DATE: 18 May 2007
REVISION: IR
AIRCRAFT: HUSKY A-1, A-1A, A-1B
SUBJECT: Wheel Brake Mounting Bracket Weld

This is to certify that I have inspected the Wheel Brake Mounting Bracket weld on Husky A-1 A-1A A-1B , Serial Number _____, Registration Number _____, in accordance with Service Bulletin No. 20 and found the following results. Additionally, modifications were performed on all welds which did not meet the new specification described in Service Bulletin No. 20.

Figure 5-1 Location of Weld to be Modified-Shown on Left Landing Gear Strut Assembly (fairing removed for clarity) – Top View

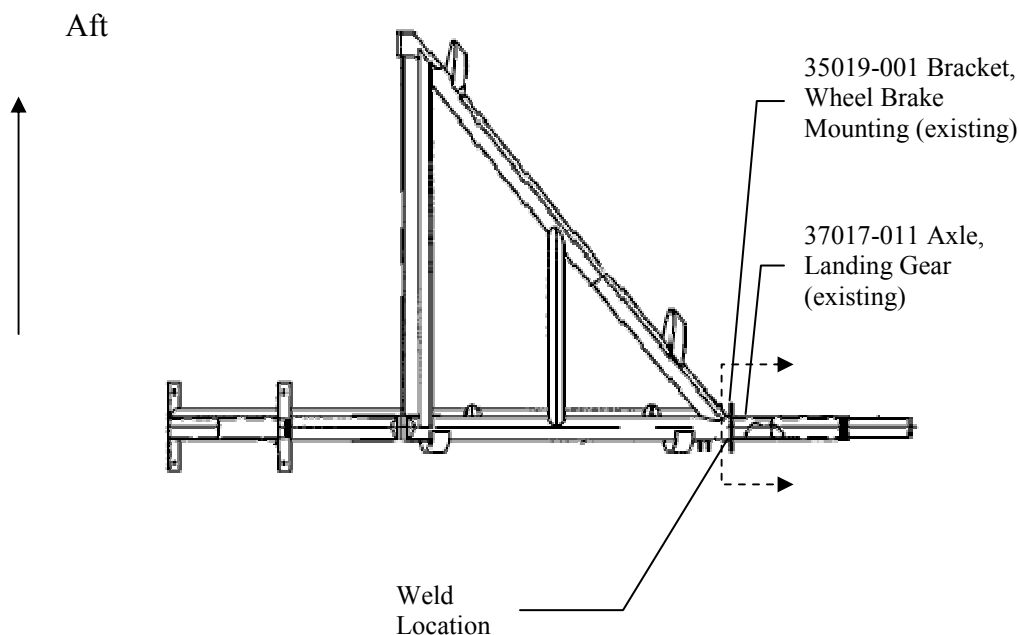
This bulletin pertains to the fillet weld on the main gear axle attaching the Wheel Brake Mounting Bracket identified in Figure 5-1.

Figure 5-2 Weld Detail for Axle and Bracket

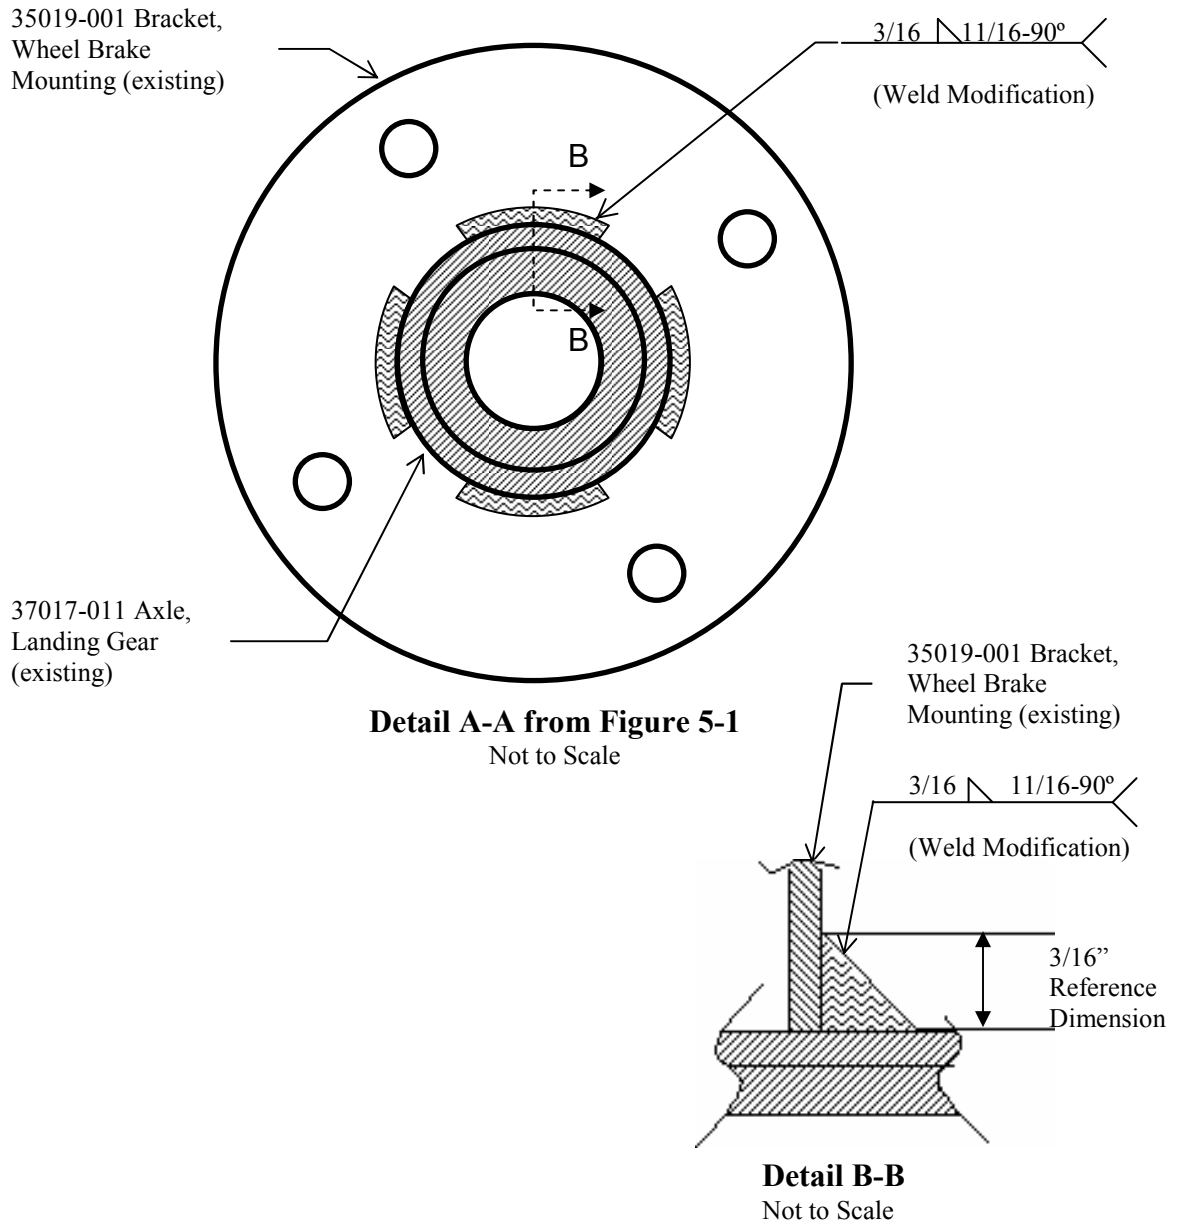
The modification entails increasing the fillet weld size to 3/16 inches. On early models, the factory fillet weld was specified at 3/32 inches. This must be increased to 3/16 inches to increase the margin of safety. The running lengths of each of the 4 fillets welds per gear will remain unchanged. A detailed view of the new weld specification is contained in Figure 5-2.

10. The modification only entails increasing the fillet size of the existing weld; the length will stay the same. Complete the welding so the reference dimension of all welds is 3/16 inches or larger as drawn in Figure 5-2. There are four welds on each side of the aircraft.
